MSC Notice of Objection Form

Fishery assessment to which this objection applies	3Ps Atlantic Cod, Northwest Atlantic
Name of conformity assessment body (CAB)	Acoura
Contact details for objecting party	
Organisation(s)	Ecology Action Centre
Contact person	Susanna Drake Fuller
Address	2705 Fern Lane, Halifax Nova Scotia Canada B3K 4L3
Phone Number (including country code)	+01902-446-4840 (office), +01902-483-5033(cell)
Fax Number (including country code)	+01902-405-3716
Email address	marine@ecologyaction.ca

Figure 6 from DFO 2015.

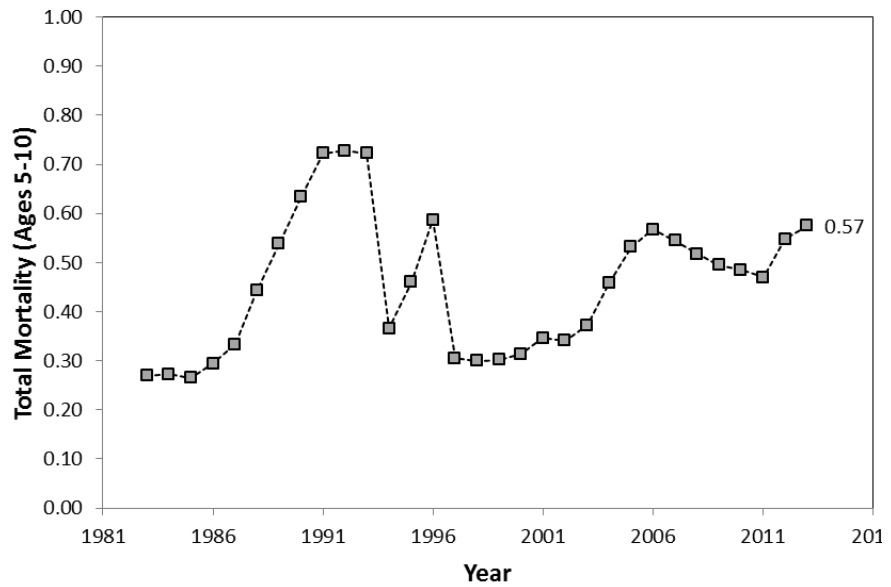
c) <i>Performance Indicator</i>	1.1.1 Scoring 80
<i>Condition</i>	1
a) <i>Reason</i>	The condition states that by the end of the third year of certification it has to be demonstrated that the stock is at or fluctuating around its target reference point . Notwithstanding that the target reference point is unrealistically low, as is addressed under CD 2.7.2.2, The current SSB is well below the target and the total mortality rate is high and increasing despite a decline in total catch. It is highly unlikely that the target will be reached in 3 years, given that the average in the time series is well below the URP.

b) <i>Rationale</i>	<p>The relative SSB exceeded the target reference point in only 2 years (2003-2004) of the 32-year time series (1983-2014). These 2 peak years occurred following a 10-year increase in SSB initiated when the fishery was closed (1994-1996) and the total mortality rate for the stock was relatively low. These facts indicate this condition cannot be fulfilled.</p>  <p>Figure 5 from DFO 2015.</p> <p>Since then the total catch in the fishery has declined, the annual TACs have not been taken, and the total mortality rate has increased.</p>

(While new data cannot be introduced at this time, it is our understanding that a new stock assessment conducted since the certification report was prepared, indicates the SSB is now further from the target and the total mortality rate is higher.)
